APPEAL SUMMARY

Project Address: 5310 NE 42nd Ave
Appellant Name: Josh Brandt
Appellant Phone: 503.226.1575
Plans Examiner/Inspector: Catherine Heeb
Stories: 1 Occupancy: A-3, B, E Construction Type: III-A (E bldg), V-B (N bldg)

Building/Business Name: De La Salle North Catholic High **Fire Sprinklers:** Yes - New and existing buildings

LUR or Permit Application No.: 19-256420-CO

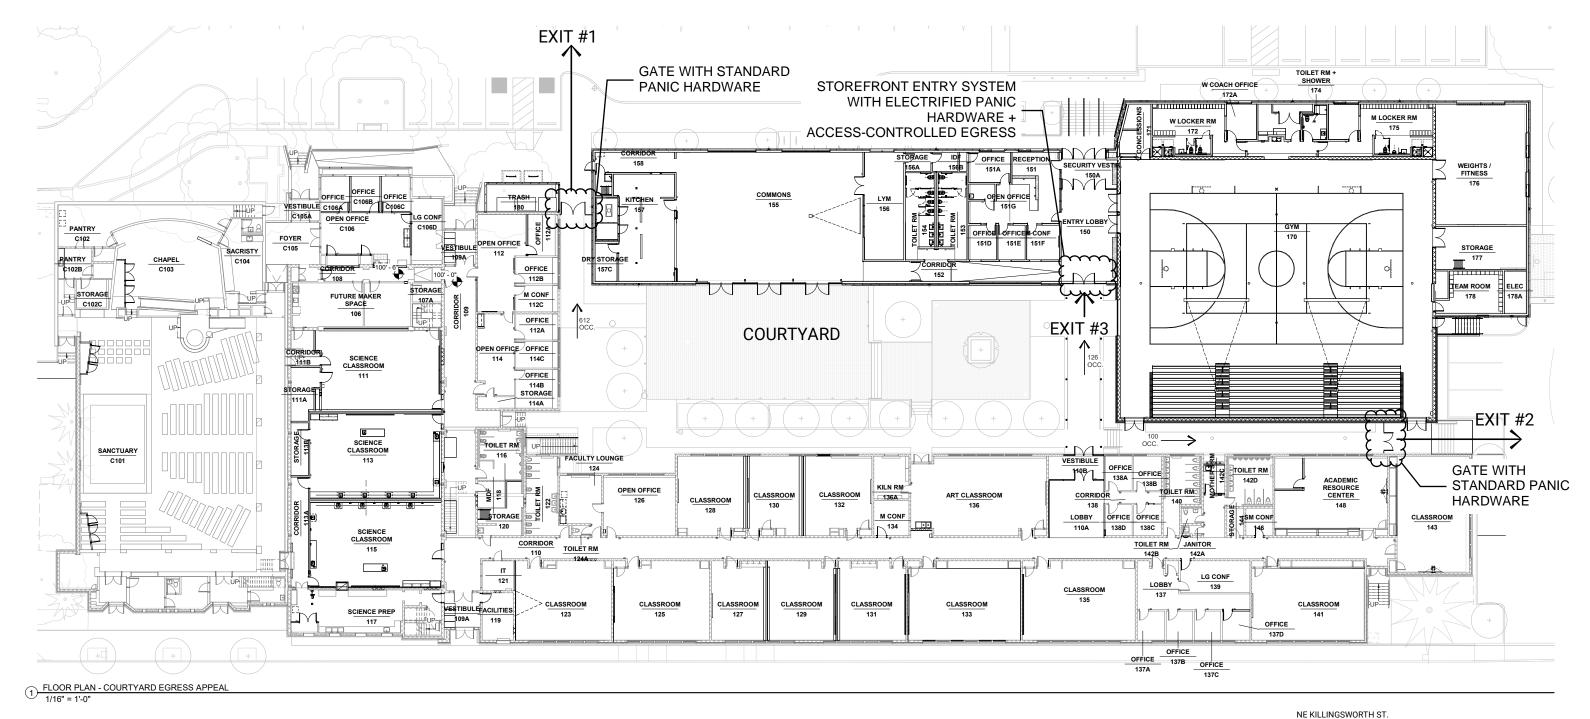
The courtyard that is created between the new and existing buildings will be an enclosed, secure space for school events, as well as a space for church functions and other rental opportunities. The courtyard is designed so that the only egress load is from the courtyard occupants themselves, plus 250 occupants from the worst-case gymnasium occupant load. Total occupant load in the courtyard is XXX, so three exits are required -- the two egress courts directly to exit discharge, and the third exit is through the lobby of the new building.

The school is understandably very concerned about security; the two egress courts from the courtyard are secured by gates to prevent access, but the concern remains that after hours an intruder could scale the gate and gain access to the new building via the egress doors that swing in the path of travel into the building.

The school is seeking to fully secure the third exit from the courtyard after hours, when the building is unoccupied, such that an intruder in the courtyard would have no access to the building interior, but would still have two means of egress from the courtyard. We seek to provide a door that complies with 1008.1.9.8 with two exceptions:

omit the sensor required by 1008.1.9.8.1 omit the "Push to Exit" button required by 1008.1.9.8.3

The doors would be operable during regular business hours and at any time when the campus is occupied, and will be "fail-safe" by design.

> For the scenario we are proposing, where the egress restrictions would only be in effect when the building is unoccupied, the only occupant load within the courtyard would be an intruder who has gained unauthorized access to the courtyard. In that situation, a third exit would not be required due to the low number of intruders in the courtyard (presumably less than 50 at one time!), and the two direct exits from the courtyard with standard panic hardware would serve the occupant load.

> From a life safety perspective, the new and existing buildings are both protected with fire sprinklers and fire alarm system, and the door will go into fail-safe mode in any/all of the scenarios spelled out in the code: loss of power, sprinkler activation, or fire alarm activation. And in all situations, two means of egress from the courtyard will remain operational.

Omission of sensor and exit button on access controlled egress door: Granted as proposed.

The Administrative Appeal Board finds that the information submitted by the appellant demonstrates that the approved modifications or alternate methods are consistent with the intent of the code; do not lessen health, safety, accessibility, life, fire safety or structural requirements; and that special conditions unique to this project make strict application of those code sections impractical.
